DORMITORY PROJECT

Regarding the **BATES SCHOOL PROPERTY**, there are many costly and hazardous concerns that your **DORMITORY PROJECT** that exceed the concerns of student parking and access that were brought up at the meeting January 5.

Figure 8. 3/4 Access Median Design

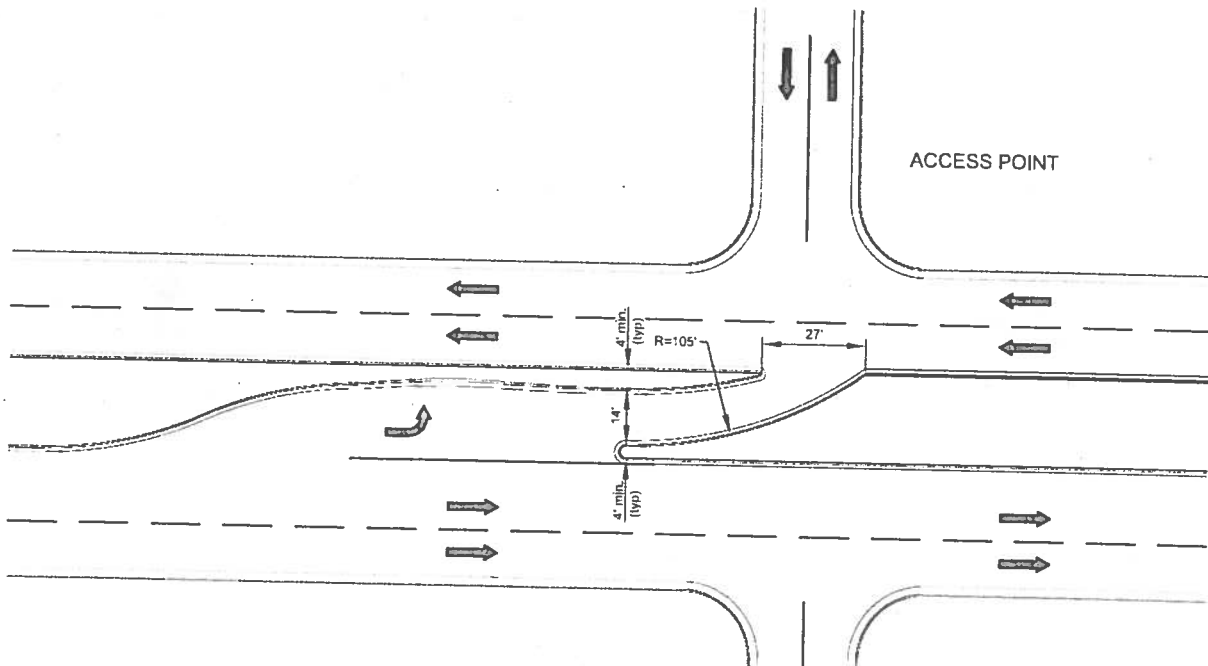
Figure 8 shows the City's standard design for 3/4 access points. As shown, this design requires a median width of 22 feet, but City Engineering has indicated that a median width of 17 feet from back of curb to back of curb would be sufficient width for a 3/4 access. Field measurements show the existing median to be 16-19 feet in width which may be sufficient to accommodate a left turn lane.
